Roof WR17 alterations to stone cut outs for brattishing rails

Page 2 of 2 - Chimney CS14 north end

OTH-PUR-TH-RF-SKE-A-3571

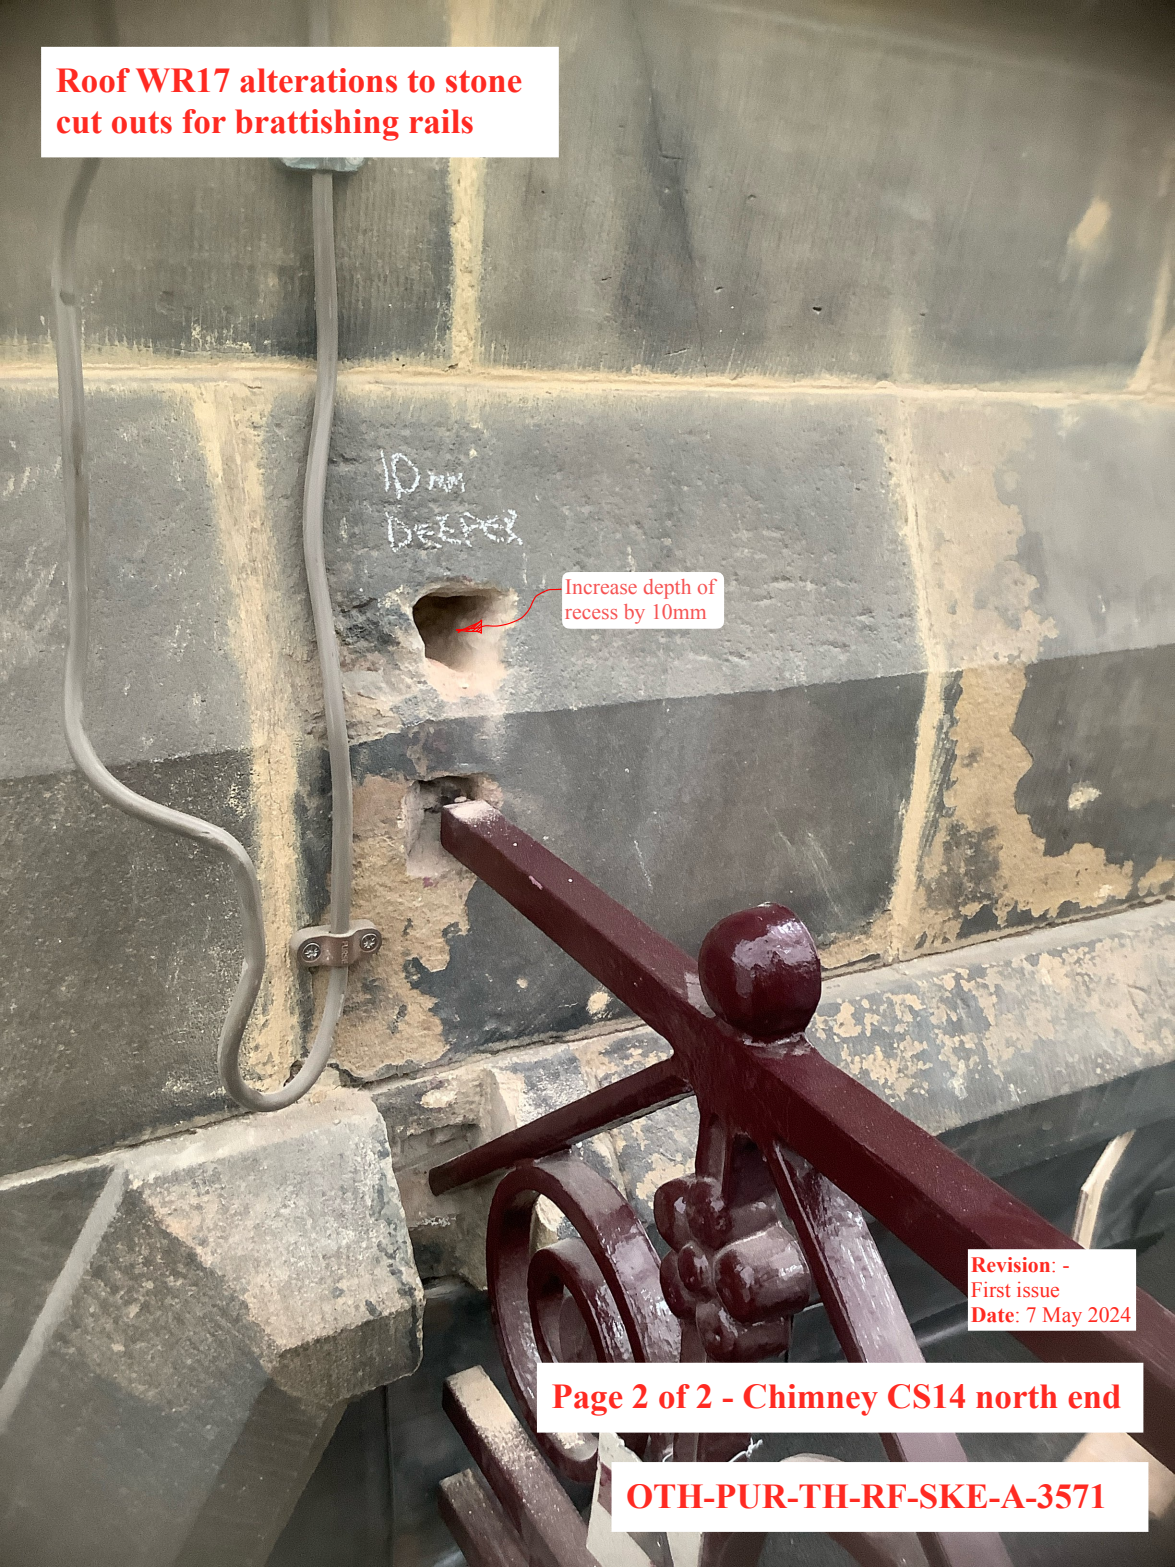
Remove all mortar from cut out recess. Extent of cut out required marked in chalk

Remove all mortar from cut out recess. Extent of cut out required marked in chalk
